CITY OF NEWTON, MASSACHUSETTS
Department of Planning and Development
Michael J. Kruse, Director

DATE: October 5, 2007

SUBJECT: **#275-07 DENNIS & SVETLANA MIRVODA** petition for a SPECIAL PERMIT/SITE PLAN APPROVAL to alter by more than three feet the existing contours of land to install a retaining wall at 121 HARTMAN ROAD, NEWTON CENTRE, Ward 8, on land known as Sec 82, Blk 15, Lot 45, containing approx 10,424 sf of land in a district zoned SINGLE RESIDENCE 2.

Re: Special Permit – 121 Hartman Road Retaining Wall

Landscape Base Map
121 Hartman Road
Newton, MA 02459
By
SDJ LLC
Natick, MA 01760
Tel: 508-545-2305

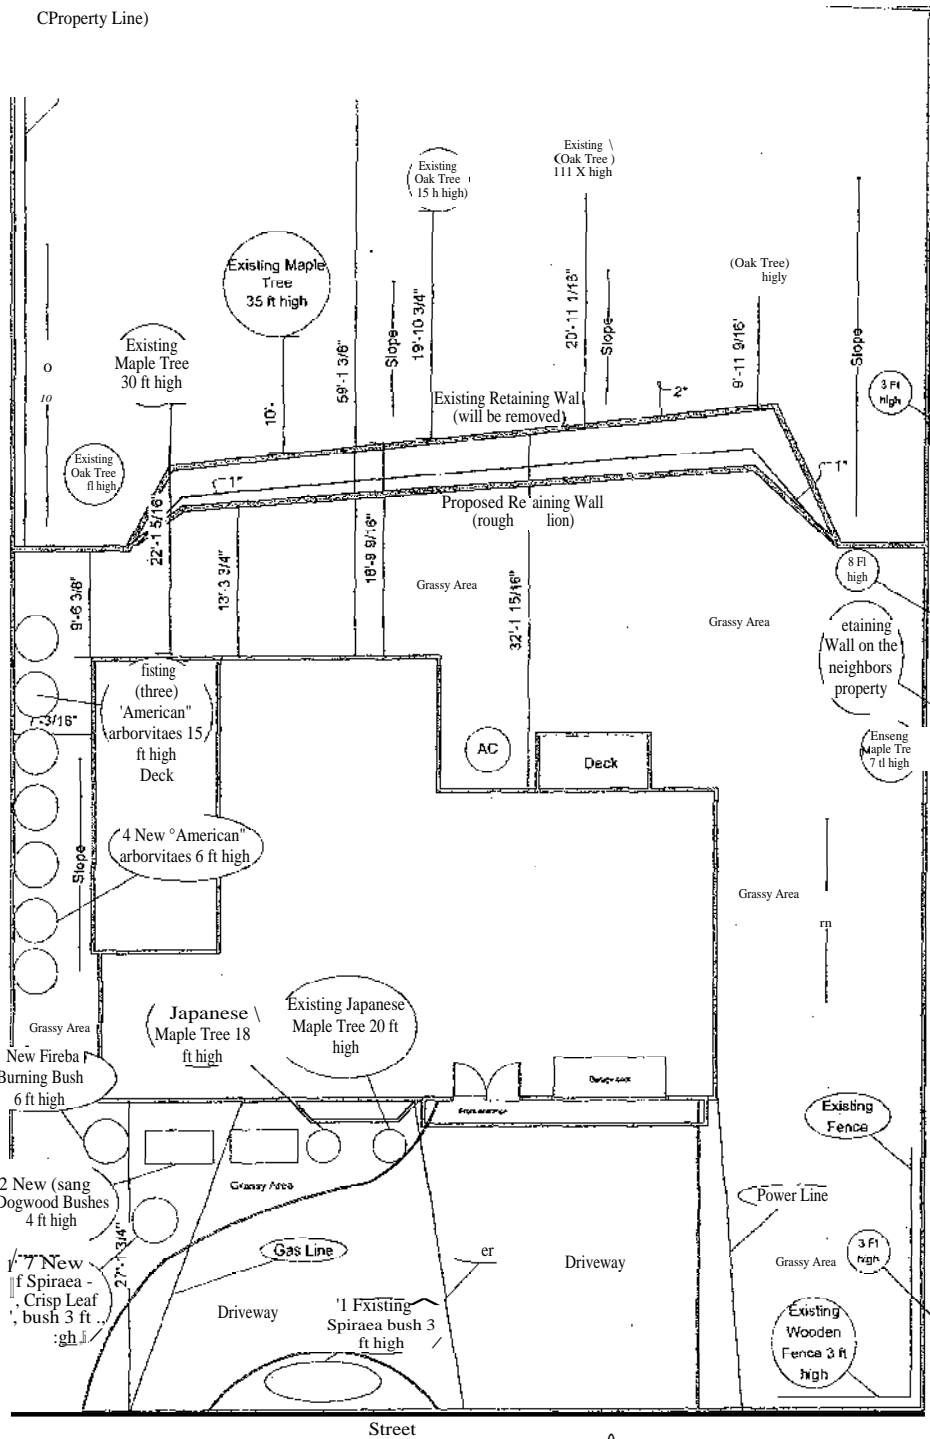
The petitioners submitted a landscape plan, dated October 1, 2007 (*SEE ATTACHMENT "C"*), showing existing plantings on the subject property. The southwest side of the lot is already partially landscaped and additional arborvitae and other shrubs are proposed as infill. Planning Department staff note that the landscape plan calls for an additional Burning Bush, which is on the ***"Do Not Plant"*** list maintained by the Massachusetts Department of Environmental Protection. ***The petitioners should be expected to identify an alternative evergreen species for that location.***

The Planning Department believes the petitioners should install additional landscaping to provide screening of the retaining wall from the street. The City has no guarantee that the petitioners will construct an addition that would provide the necessary screening. Once the re-grading and retaining wall are completed, the petitioners should install evergreen plant material of at least 3 ft. in height between the house and the west property line.

The Planning Department recommends that all areas of backfill be supported by anchored, bio-degradable netting, such as jute, to support the fill (and so indicated on the landscape plan). The netting should extend beyond the backfill and up the slope to protect the existing trees and ground cover. In addition, the landscape plan should indicate that a ground cover, appropriate for the soil and other conditions, will be installed within the biodegradable netting. The netting and the plant materials together will ensure that the backfill is stabilized and allow landscape materials to become established on the slope.

In addition, the Planning Department expects the petitioners to update the submitted landscape plan to show:

- *a retaining wall faced with natural stone,*
- *installation of evergreen shrubs at least 3 ft. in height to provide screening on the west side of the property,*
- *appropriate stabilization of the backfill and slope, and*
- *an appropriate ground cover for the soil and tree conditions.*
